August 27, 2009

Subject: UniStar Nuclear Energy, NRC Docket No. 52-016
Response to Request for Additional Information for the
Calvert Cliffs Nuclear Power Plant, Unit 3,
RAI No. 58, Seismic Design Parameters, Questions 03.07.01-3 and 03.07.01-5

Response to NRC Request for Additional Information, Seismic Design Parameters, Questions 03.07.01-3 and 03.07.01-5, Calvert Cliffs Nuclear Power Plant, Unit 3

Figure 1. Randomized Shear-Modulus and Damping Degradation Curves for Terrace Sand Material Used for Assumed Structural Backfill.

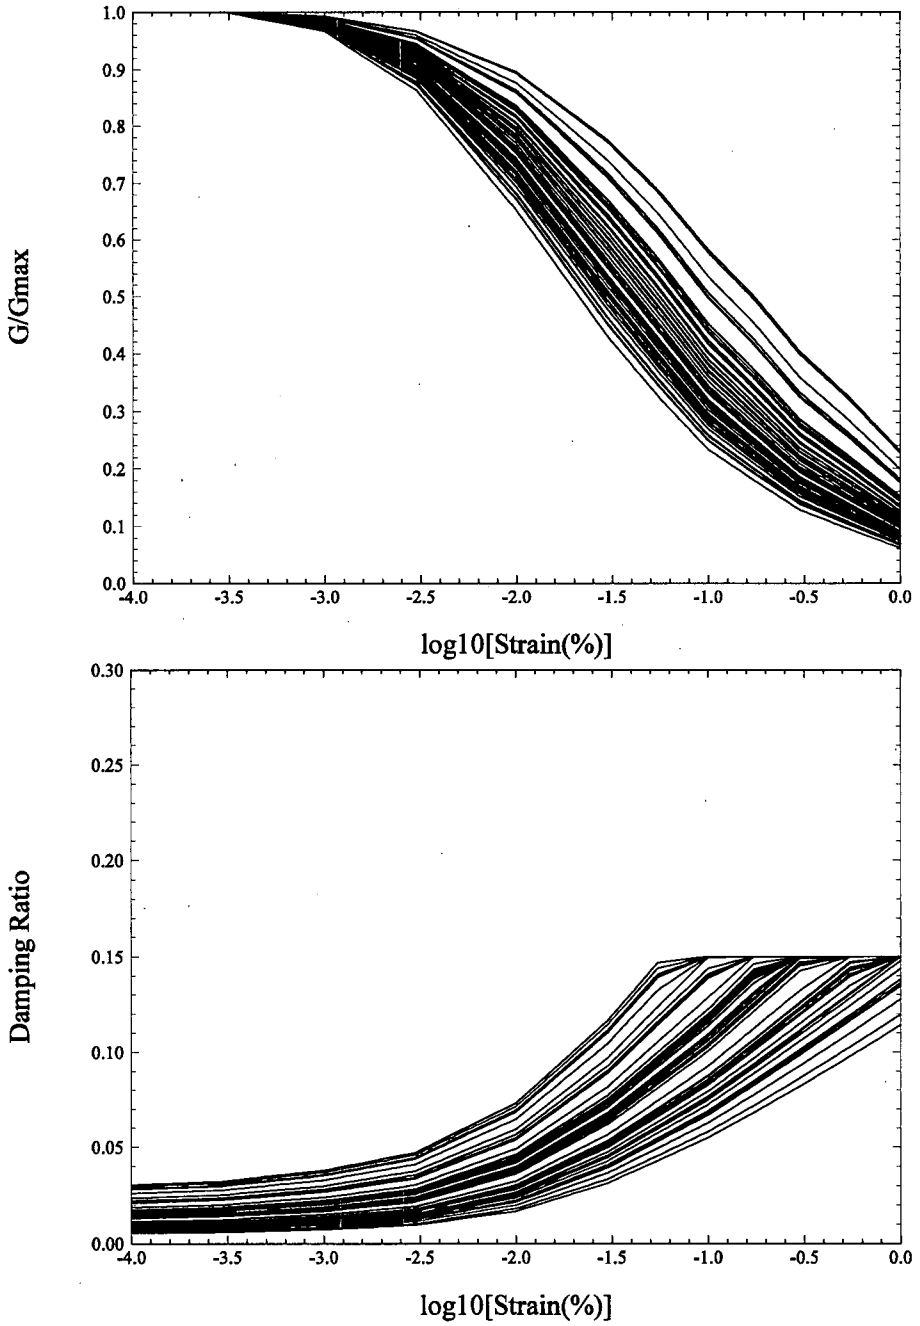
- How were the FIRS at grade elevation computed from the GMRS which were determined at an elevation 12.5 m (41 ft) below grade? Include in the response, computer codes, soil column model, and the basis for the shear wave velocity of the structural backfill that supports both the EPGB and ESWB and the impact of this backfill on the development of the FIRS?

Soil profile provided in FSAR Tables 2.5-51 and 2.5-53 is used for depths greater than 41 ft. The structural backfill properties considered in the analysis for the top 41 ft are provided in Table 1. The shear-wave velocity used for the top 41 ft of backfill corresponds to the in-situ soils (25 ft of Terrace Sands above 16 ft of Chesapeake clay/silt). Due to unavailability of the actual backfill properties, these values were considered representative of the structural backfill material at the time of writing the FSAR. Similarly, the unit weight and degradation curves for the Terrace sands were also considered representative of the backfill properties (see FSAR Table 2.5-53 and Figure 1 below). The dynamic properties for the in-situ soils are based on Resonant Column Torsional Shear (RCTS) Tests and are randomized as shown in Figure 1.

Figure 4: Calvert Cliffs Site SSE 5% damping spectrum (horizontal and vertical)

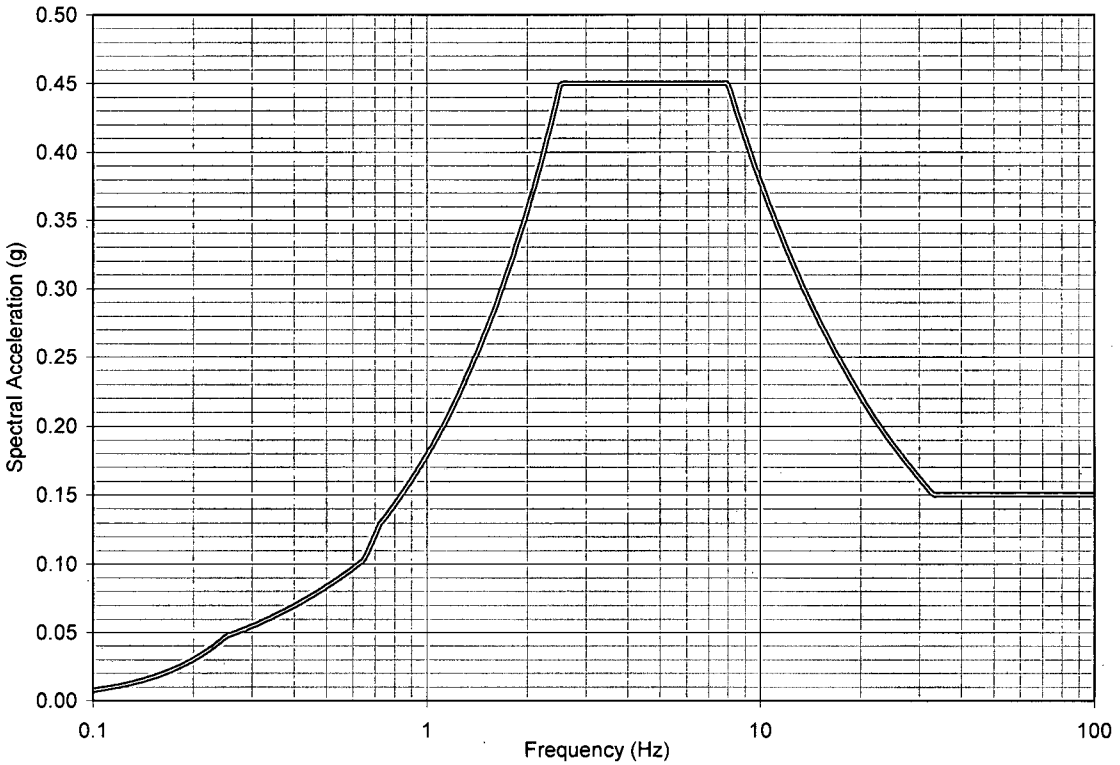
In FSAR Section 3.7.1.1.1 on page 3.0-33, it states that the design response spectra for the Ultimate Heat Sink Electrical Building (UHS EB) is conservatively established by an envelope of half the magnitude of the EUR soft soil spectrum with a zero period acceleration (ZPA) of 0.15 g and the In-Structure Response Spectra (ISRS) developed at the operating deck of the UHS makeup water intake structure (UHS MWIS). Since this is the seismic design input for this structure, provide and include in the FSAR the horizontal and vertical spectra depicting these design spectra envelopes. In addition, provide in the FSAR a reconciliation of the design response spectrum with the horizontal foundation input response spectra (FIRS) for this structure which meets the minimum requirements of 10 CFR Part 50, Appendix S. Also, include a description of how the FIRS are developed including the soil model, soil properties, backfill properties, computer programs and analysis assumptions.

Figure 4 depicts the one set of horizontal and vertical Calvert Cliffs Site SSE spectra, which replaces the two sets of spectrum described above and included in FSAR Section 3.7.1.1.1. This spectrum will be used for the SSI analysis of the UHS EB integrated with UHS MWIS and other structures in the vicinity. The development of this smooth broad band spectrum is discussed in the response to RAI 58 Q03.01.07-4[1]. The results of the SSI reconciliation analysis and justification of Calvert Cliffs Site SSE spectrum as design spectra for UHS EB will be provided at a future date with responses to RAI No. 65 Questions 03.07.02-4 and 03.07.02-12 according to the schedule provided in Enclosure 1.
